ISSUE: Certificate of Appropriateness for new construction

APPLICANT: City of Alexandria and Washington Metropolitan Area Transit Authority (WMATA)

LOCATION: Old and Historic Alexandria District
2500 Potomac Greens Drive (2405, 2501, 3701 Potomac Avenue, 3251 Potomac Avenue [Parcel ID 016.04-01-01], 700 Carpenter Road, 1702 and 1880 Potomac Greens Drive) 2901 Potomac Avenue (2405, 2501, 3701 Potomac Avenue, 3251 Potomac Avenue [Parcel ID 016.04-01-01], 700 Carpenter Road, 1702 and 1880 Potomac Greens Drive)

Potomac Yard Metrorail Station

18. Provide Additional Information on the Entrance Pavilion

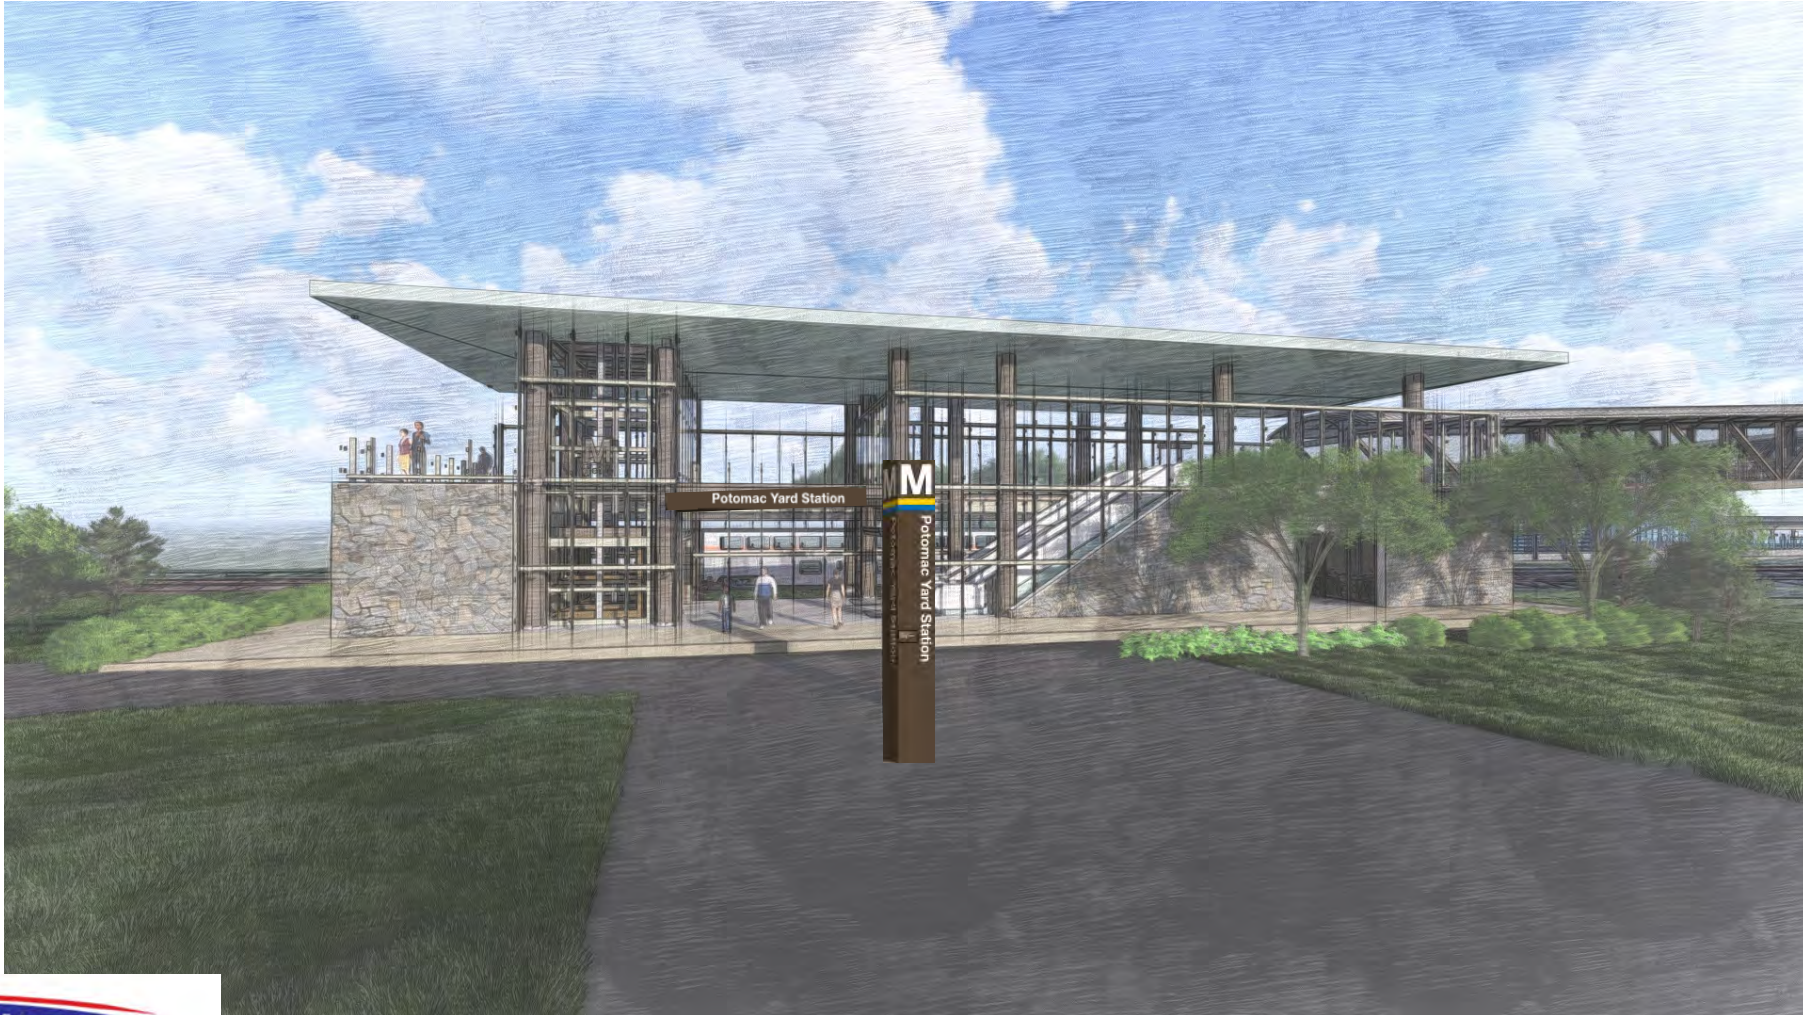
However, the architectural details of the pavilion have not been advanced from the concept review. For instance, no lintels are shown over the openings in the fieldstone walls. While longer pieces of cut stone may have visual structural support, fieldstone does not. Staff suggests that either lintels be expressed or the stone for the entrance be the same stone as the station but in a random ashlar pattern. In addition, there is no coping shown at the top of the stone walls. It is also not clear from the soft colored renderings what the mullion and support system is for the glass walls. These fundamental architectural details on the exterior of a structure are a normal part of the BAR's review.

Item	Status
17.	Restudy platform mesh to a style with a heavier horizontal wire or extend the glass curtain wall	Open – to be presented at tonight’s meeting
18.	Provide Additional Information on the Entrance Pavilion	Open – to be presented at tonight’s meeting
